HISTORIC AND DESIGN REVIEW COMMISSION

HDRC CASE NO: 2019-379
ADDRESS: 910 N HACKBERRY ST
LEGAL DESCRIPTION: NCB 530 BLK 14 LOT N 79.02 FT OF A-4 & NW IRR 34.93 FT OF A-5
ZONING: R-5, H
CITY COUNCIL DIST.: 2
DISTRICT: Dignowity Hill Historic District
APPLICANT: Cy Goudge/JCG Homes
OWNER: JCG Homes, LLC
TYPE OF WORK: Construction of two, 2-story residential structures
APPLICATION RECEIVED: June 21, 2019
60-DAY REVIEW: August 20, 2019
CASE MANAGER: Edward Hall
REQUEST:

The applicant is requesting conceptual approval for construction of two, 2-story, residential structures on the vacant lot at 910 N Hackberry, located within the Dignowity Hill Historic District. At this time, the applicant has provided a site plan and information regarding height for review.

**Historic and Design Review Commission
Design Review Committee
Report & Recommendation**

SCHEMATIC SITE PLAN
1/8"=1'-0"

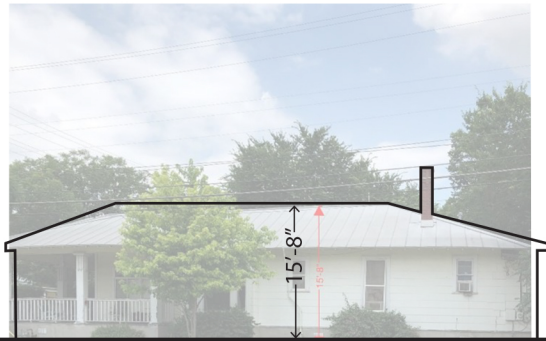
- i. LOT COVERAGE – Per the Guidelines, the building footprint for new construction should be no more than fifty (50) percent of the size of the total lot area. The applicant has submitted a site plan which appears to be appropriate; however, the applicant should confirm that the proposed lot coverage is consistent with the Guidelines.

- j. DRIVEWAYS – The applicant has proposed on driveway on N Hackberry and another on Fayn Way. The applicant has not noted an overall width of the proposed driveways; however, staff finds that the proposed driveways should not exceed ten (10) feet in width, per the Guidelines.

- k. WALKWAYS – The applicant has proposed two walkways leading from the proposed new construction to the sidewalk at the public right of way. The applicant has aligned both walkways with the front doors. Staff finds this to be appropriate, as offset front doors and walkways are found historically in the immediate vicinity.

- l. LANDSCAPING – The applicant has provided a site plan noting landscaping that features natural grass covering the majority of the lot. Staff finds this to be appropriate.

- m. CARPORTS – The applicant has proposed two carports, one attached, and one detached. Staff finds that the location of the detached carport is appropriate and consistent with the Guidelines; however, staff finds that the proposed attached carport should either be detached and shifted away from the front façade of the proposed structure, or eliminated. Staff does not find an attached carport to be appropriate.

- Unique lot shape to be divided to accommodate 2 houses.
- setback: edge of porch should be matching the front face plane of house across the alley (17') which is setback behind the immediate neighboring house. side setbacks should be compliant (5')
- DRIVEWAYS SHOULD BE 10' (2+6+2)

- CARPORT SHOULD FEATURE SHED ROOF
- SUGGESTED TO RETURN TO DRC AFTER ZONING APPROVAL
- LOT COVERAGE?
- HEIGHT CONTEXT → JUSTIFY 2-story flanked by 1-story.

- i. That the applicant amend the proposed setbacks to feature setbacks that are greater than those of the adjacent historic structures, including porches, as noted in finding d.

- iii. That the applicant include a foundation height that is within one (1) foot of those found historically on this block as noted in finding h.
- iv. That the applicant confirm that the proposed lot coverage is less than fifty (50) percent, per the Guidelines, as noted in finding i.

- v. That the propose driveways not exceed ten (10) feet in height, as noted in finding j.
- vi. That the proposed attached carport either be separated from the proposed new construction and shifted toward the rear of the lot, or eliminated as noted in finding m.
